Mason & Hanger-Silas Mason Company, Inc.
ATTN: R. M. Loghry
Vice President & Plant Manager
Iowa Army Ammunition Plant
Middletown, IA 52638

Enclosed is Amendment No. 03 to your NRC License No. 14-24479-01 in accordance with your request.

Subject: License No. 14-24479-01 Renewal

CONTROL NO. 89393

ATTACH

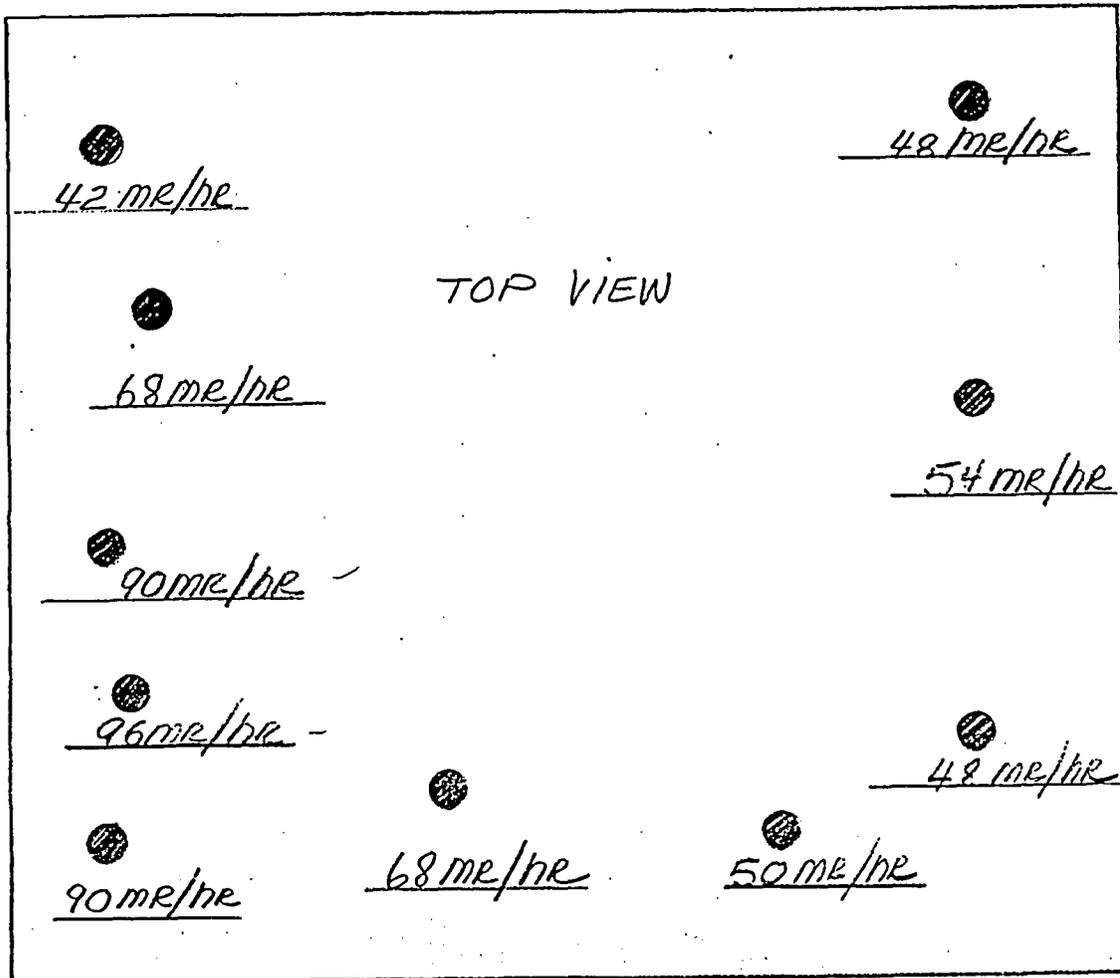
In lieu of these options we have repositioned the lead attenuation gates located in front of the collimator to reduce radiation levels below 100 mr/hr on the roof top of building 3-10. The following is a description of the actions taken:

Upon further investigation to reduce radiation levels at the roof top of 3-10, it was determined that the problem could be solved by repositioning the lead attenuation gates (see att #1, enlarged view "A" of attached drawing No. 2-10-M-1055, sheet 1 of 7). The lead gates were lowered to limit the area of exposure to the area within the maximum height of the ring (see att #2, drawing No. 3-10-S613 sheet 1 of 1, for clarification of ring orientation). This arrangement confines the radiation to the inner wall (see photo No. 3-04, included with letter dated 27 February 1990) of the vault, therefore, limiting the amount of exposure to the rooftop. To inhibit the lead gates from being raised, a maximum height gate has been installed between the top of each gate and the collimator tank flange (att #1, drawing No. 2-10-M-1055). To ensure the gates cannot be removed, a locknut has been placed on the stem of each gate. The lockout was also tapped and a roll pin was placed through the nut and stem.
